<b>Docket Number:</b>	08-AFC-09C
<b>Project Title:</b>	Palmdale Energy Project (Formerly Palmdale Hybrid Power Plant) - Compliance
<b>TN #:</b>	210594
<b>Document Title:</b>	Palmdale Energy LLC's Revised Supplemental Response to California Energy Commission Staff Data Request 55 and 58
<b>Description:</b>	N/A
<b>Filer:</b>	Marie Fleming
<b>Organization:</b>	DayZen LLC
<b>Submitter Role:</b>	Applicant Representative
<b>Submission Date:</b>	3/2/2016 12:26:27 PM
<b>Docketed Date:</b>	3/2/2016

Attached is Palmdale Energy, LLC's revised responses to California Energy Commission Staff (Staff) Data Requests 55 and 58 for the Palmdale Energy Project (PEP) Petition For Amendment. For context the text of the Data Requests precedes the Data Responses.

DWG NO  
**A01**

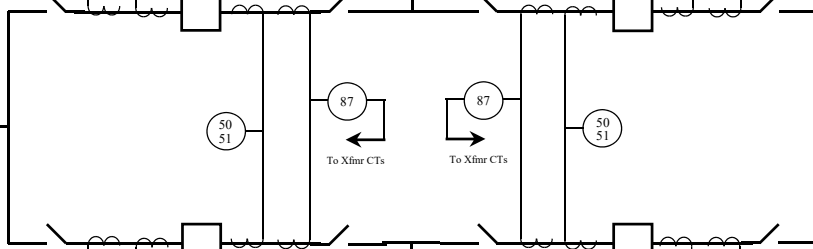
Resubmit Figure 3-1a and Figure 3-1b.

1. Show bay arrangement of the necessary equipment which is required to interconnect the project.
2. Provide ratings of the breakers, disconnect switches, relays, buses, and etc.

Palmdale Energy has revised Figure AO1 to show rating for the generators and step-up transforms, Please also note that Figure 3-1b already includes ratings for the generators and step-up transformers and, as a single line drawing of the power block.
